SERVICE BULLETIN
REVISION TRANSMITTAL SHEET

TITLE : AIR CONDITIONING - DOOR AREA HEATING - INTRODUCE AN IMPROVED CONTROL LOGIC

FOR THE ADDITIONAL HEATING SYSTEM

This page transmits Revision No. 3 of Service Bulletin A320-21-1093.

Modification to the Wiring Between Zones 210, 120 and 220 Figure 1

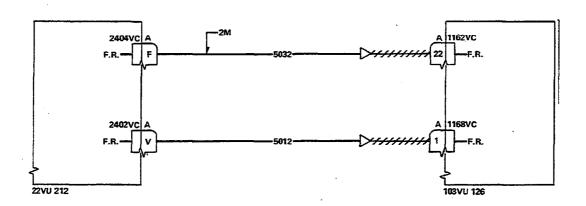
- (1) Modify the wiring between zones 120 and 210.
- (2) Modify the wiring between zones 210 and 223.
- (3) Modify the circuit breaker panel 2000VU.

Modification to the Wiring Between Zones 120 and 210 Figure 2

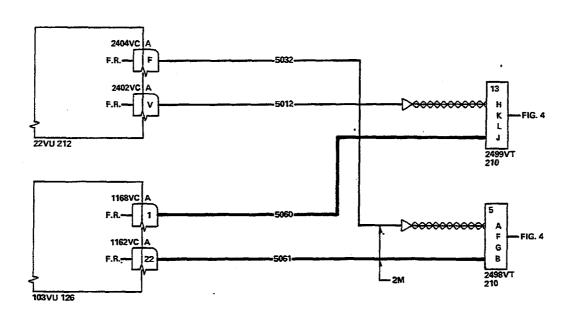
(1) Do a modification to the wiring between zones 120 and 210.

- (a) Do a modification to the wires as shown on lines 1 thru 4 (Refer to Figure 5).
- (b) Install the wires as shown on Lines 8 and 9 (Refer to Figure 5) supplied in:

Hook-Up Chart (Ref. Fig. 2, 3 and 4)
Figure 5

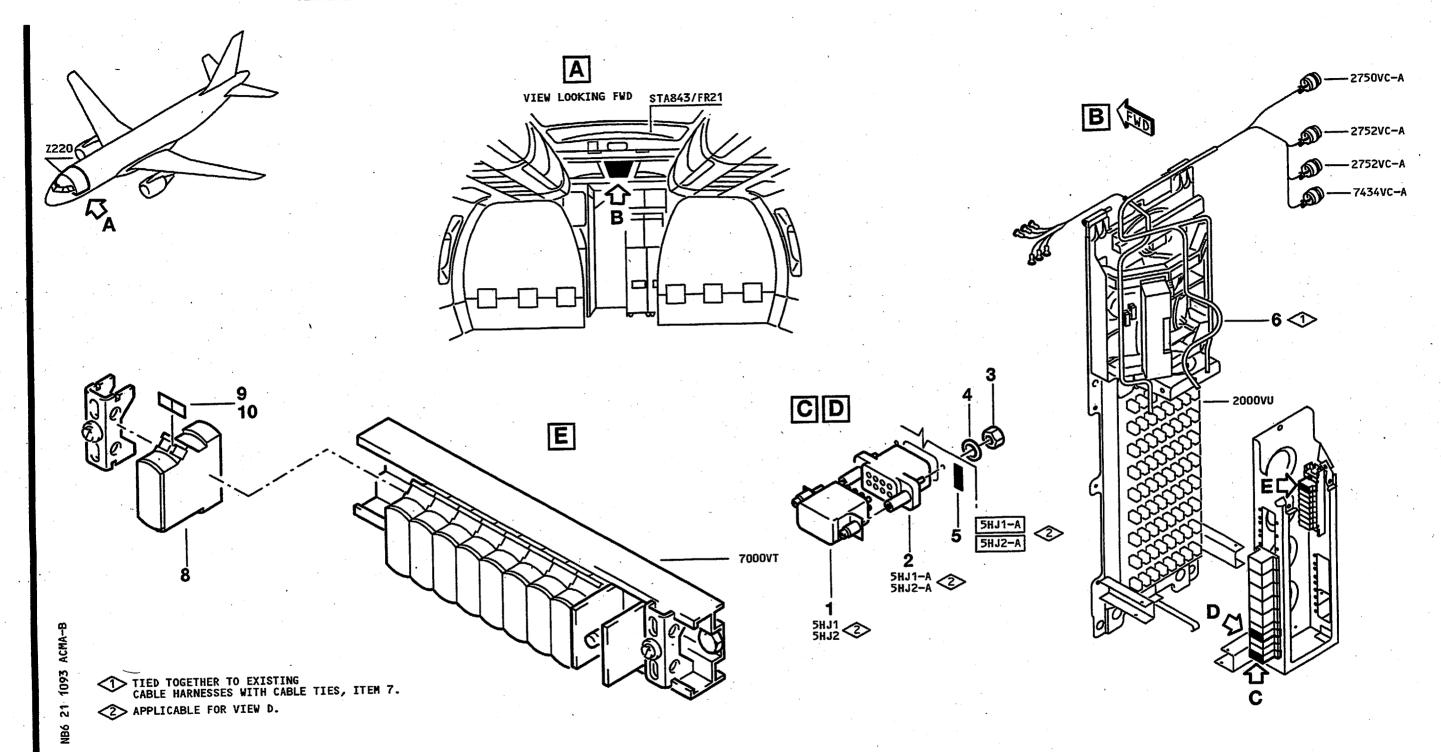
(a) Install the wires as shown on lines 11, 12, 14, 15, 16 and 17 (Refer to Figure 5) supplied in:

Installation of Relays 5HJ1 and 5HJ2 Figure 6

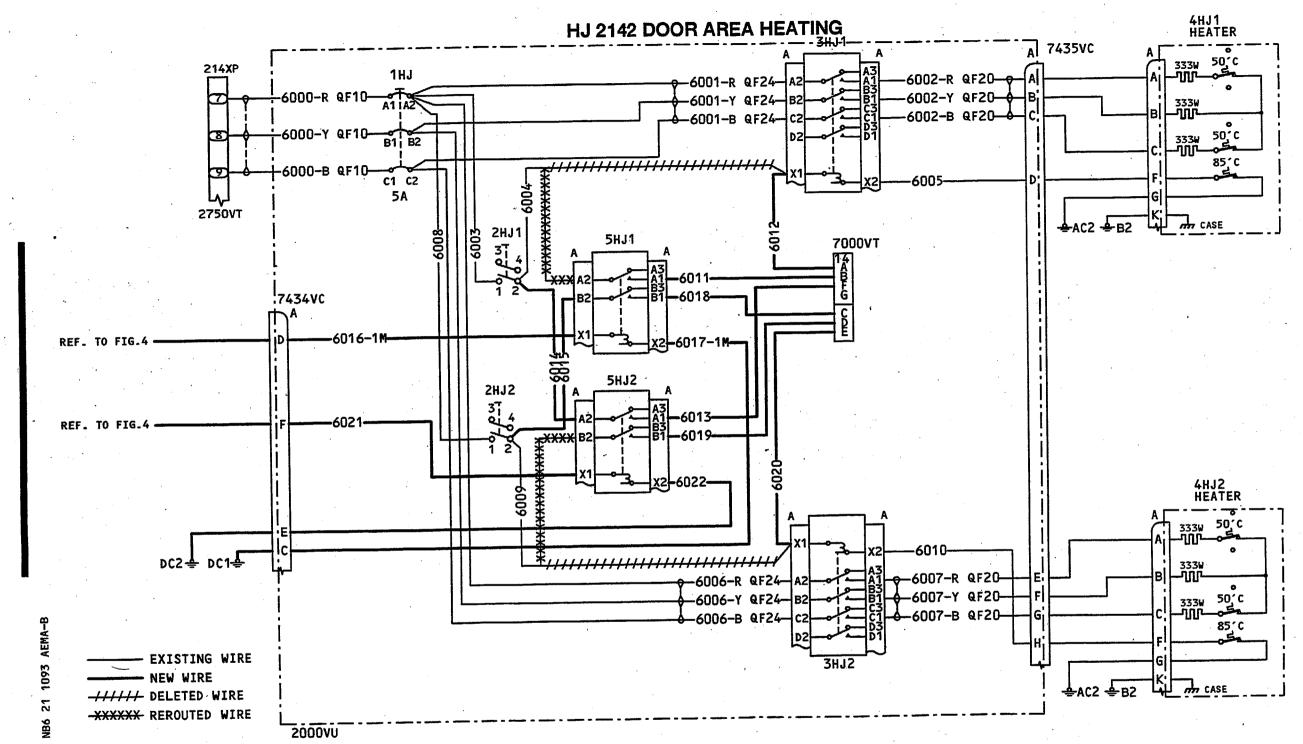
(a) Install these items on the circuit breaker panel 2000VU:

2 Relays	E024528A0	item	1
2 Bases	E0250A0S	item	2
4 Nuts	MS21042L04	item	3
4 Washers	AN96DC4L	item	4
1 Module	NSA937901M20-11	item	8
1 Label	NSA937901E1	item	9
1 Label	NSA937901E4	item	10

(b) Between the relays 5HJ1 and 5HJ2, install:
